Reliability Driven®
Service Bulletin No. 446

MODEL J4500	TYPE Field Change Program	SECTION/GROUP 3-Body	DATE June 14, 2017
SUBJECT A/C COMPRESSOR SUPPORT TUBE			
CONDITIONS

Figure 32. Idler pulley bracket angle drilled mounting hole dimensions.

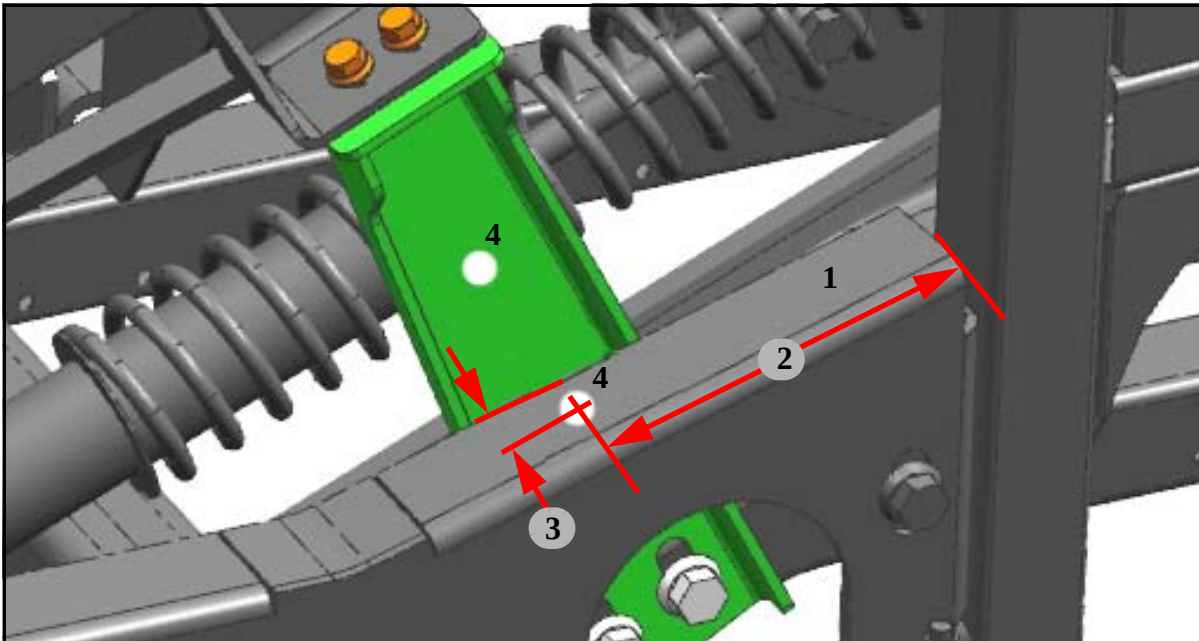
70. Using a 17/32 inch drill bit and a drill, drill a mounting hole in the tie bar plate per the dimensions shown in Figure 32.

Item	Figure 32 Description
1	Tie bar plate
2	6.00 inch
3	0.87 inch
4	Mounting holes

Figure 33. Idler pulley bracket angle and snubber bracket installation.

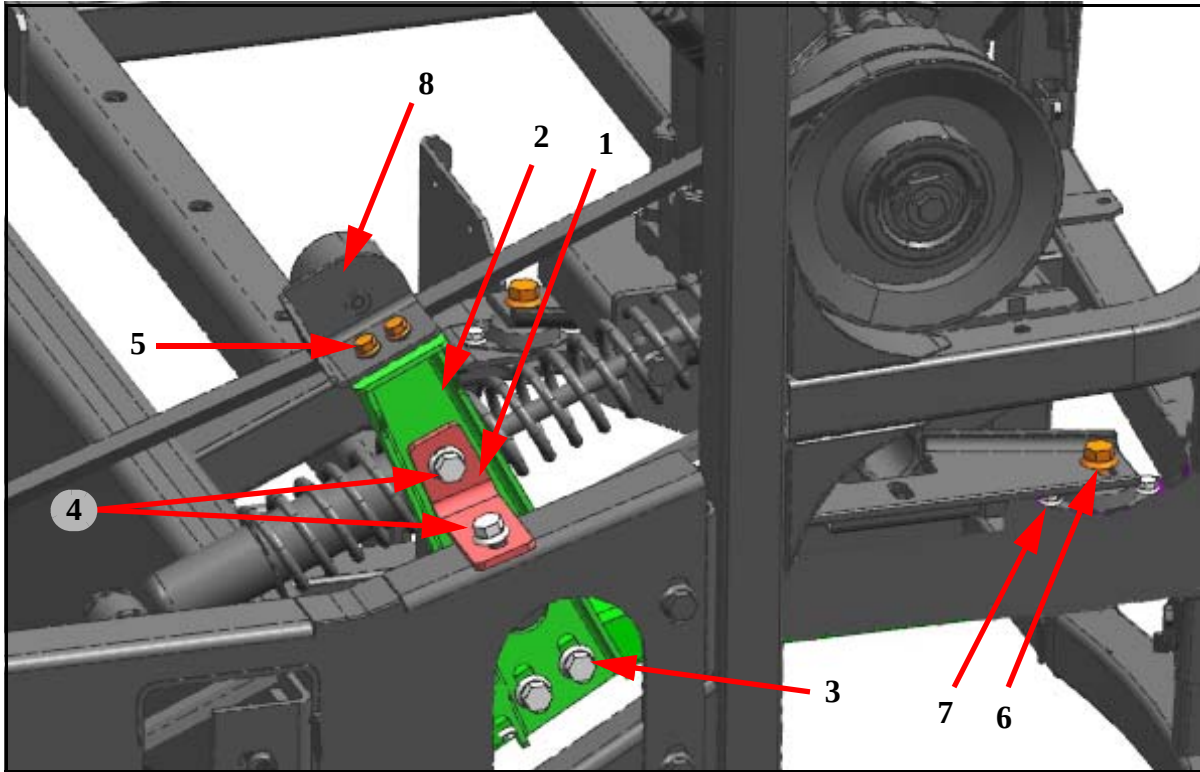
71. Orient and install the new snubber bracket, p/n 08-27-1327, idler pulley bracket angle, p/n 08-27-1326, and existing idler pulley as shown in Figure 33.

Item	Figure 33 Description
1	Angle, idler pulley bracket
2	Snubber bracket
3	Snubber bracket cap screw, p/n 19-01-1526 and flange nut, p/n 19-03-0497. Torque to 77-93 ft.-lbs
4	Angle cap screw, p/n 19-01-1577 and flange nut, p/n 19-03-0497. Torque to 77-93 ft.-lbs
5	Idler pulley cap screw, p/n 19-01-1570 and lock nut, 19-03-0535. Torque to 43-47 ft.-lbs
6	Compressor stabilizer, ref p/n's 19-01-1529, 19-03-0497. Torque to 63-77 ft.-lbs
7	Stabilizer to brackets, ref p/n's 19-01-1532, 19-03-0498. Torque to 14-16 ft.-lbs
8	Idler pulley

Figure 34. Addition of shim(s) to achieve a 3/8 inch belt deflection.

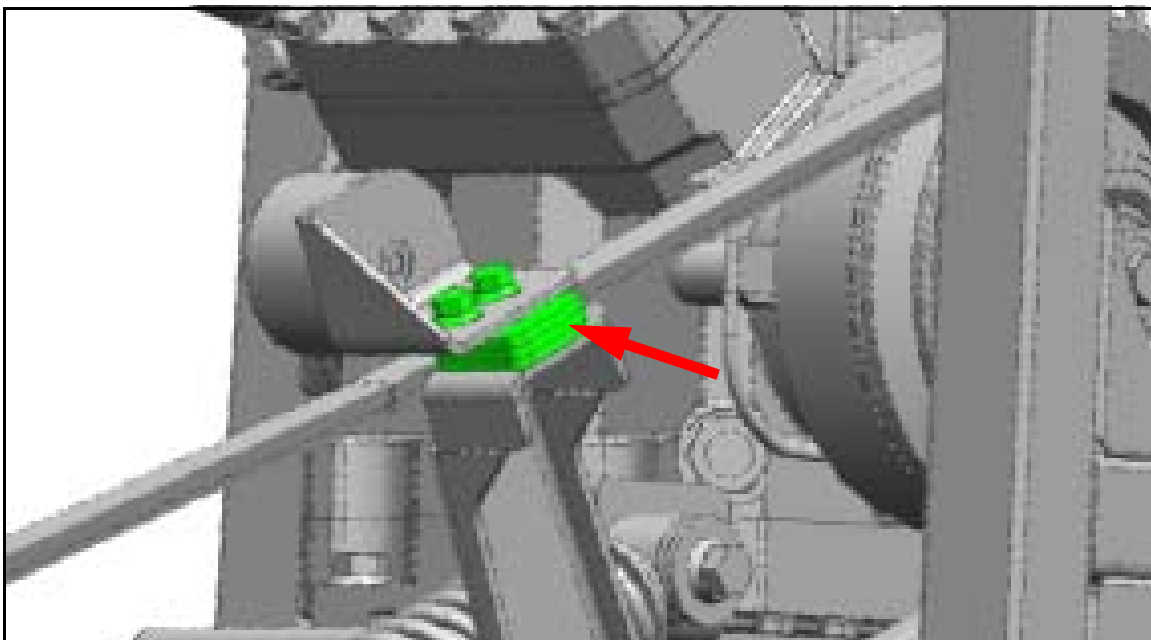
73. Remove the capscrew, p/n 19-01-1570 and lock nut, 19-03-0535 mounting the idler pulley to the snubber bracket. Orient and position the required quantity of shims, p/n 08-27-1324, between the idler pulley bracket and the snubber bracket (refer to Figure 34).
74. Orient and install new capscrews, p/n 19-01-1736, through the idler pulley holes and the shim(s). Install the locknuts, p/n 19-03-0535, on the capscrews. Torque to 43-47 ft-lbs.

Only utilize a quantity of shims (one to three) that achieves a 3/8 inch belt deflection.
